# **MODIFICATION REQUESTS:**

Pitt Town Concept Plan (MP07\_0140 MOD 3 and MP07\_0140 MOD 4)

Modification to residential subdivision layout including modifications to roads, number of allotments and allotment layout within the Blighton Precinct.

Secretary's
Environmental Assessment Report
Section 75W of the
Environmental Planning and Assessment Act 1979

Figure 3: Approved Masterplan, as amended by condition B2 requiring amalgamation of the south-western allotments into 3 allotments.

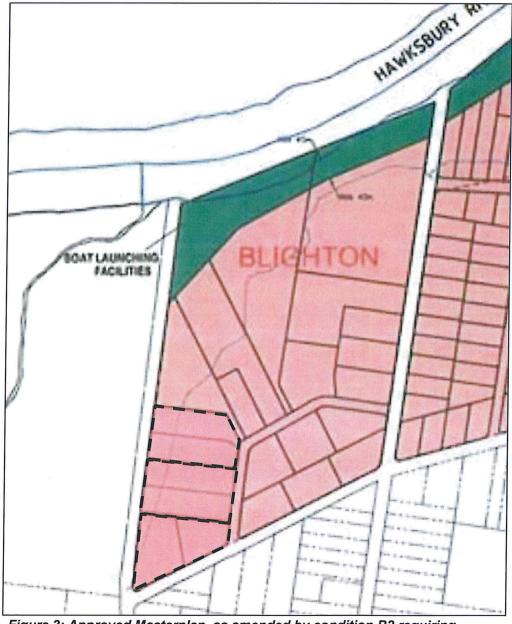
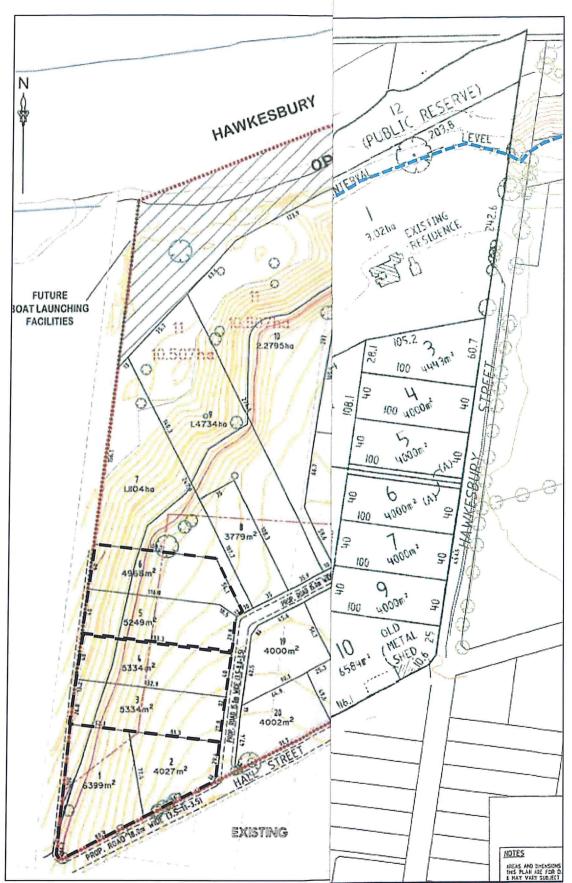
At the time of the assessment of the original Concept Approval, the NSW Heritage Office recommended that the number of lots bordering on the western boundary of Blighton, facing the historically significant area known as the Pitt Town Bottoms (to the west of the site) be reduced from six lots (as proposed) to three lots to maintain the open vista of land that was formally part of Governor Bligh's Farm. This was implemented through Condition B2 imposed on the approval (refer to **Figures 3** and **4**).

On this basis, the proposed change to the subdivision layout will not result in any unacceptable impacts to the heritage values of the precinct or the conservation area. The Department also recommends that Condition B2 be deleted as the modified layout provides 3 lots along the western boundary of Lot 11, consistent with the Heritage Council recommendation in the original Concept Approval.

Figure 7: Proposed plans indicating minimum lot sizes (note: proposed Lot 11 in Lot 11 does not meet the lot size but is not proposed for residential use)

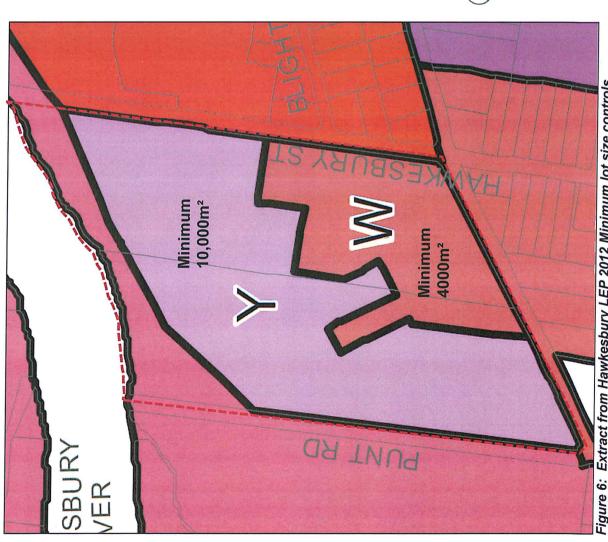
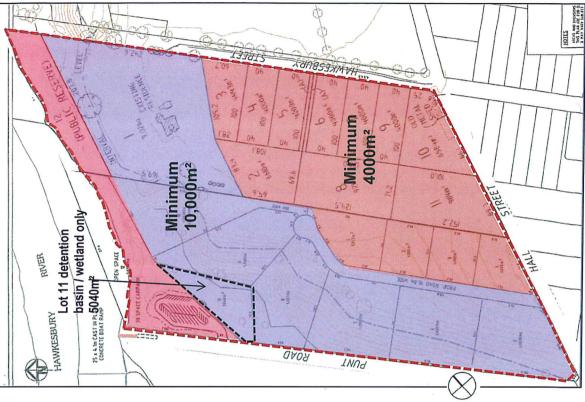
The modification request adopts a similar format, with smaller allotments (minimum size of 4,000m²) in the south east-corner of the site and larger allotments with a minimum size of 10,000m² elsewhere. However, due to the changes arising from the new road location and design and the rationalisation of the allotment layouts, the modified layout would not strictly comply with the LEP controls (which were based on the approved layout) (compare **Figures 6** and **7**). The variation is able to be considered on its merits under Part 3A.

Therefore, despite the variation from the minimum lot size controls in the LEP, the proposed modifications have been designed to address the heritage and flooding constraints that gave rise to the approved layout (refer to detailed discussion in **Sections 5.2** and **5.3** below) and are consistent with the relevant objective of the control which is to ensure lots contain a suitable area for the erection of a dwelling house.

On this basis the proposed changes to the lot sizes and layout are acceptable.

Figure 11: Propsoed boat ramp and parking layout

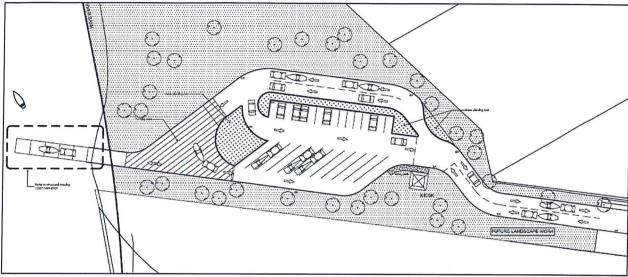
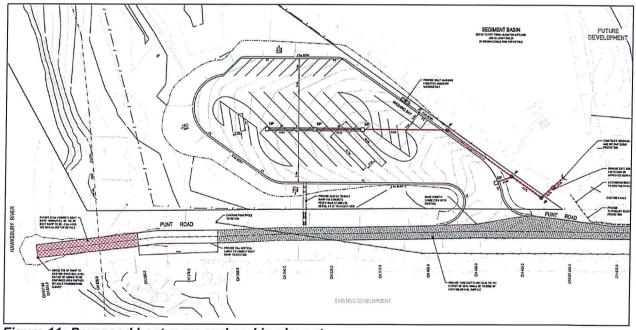
The Concept Approval also includes a boat ramp with associated car and trailer parking within the road reserve and designated open space at the northern end of Lot 11. The modification request (Modification 4) includes an amended indicative design layout for the car park (compare **Figures 10** and **11**). The Council has not raised any objection to the proposed modified layout. The amended plan will be referenced in Condition A2, however as the layout is indicative only, it will be subject to future approval of a development application, where the final design will be determined.
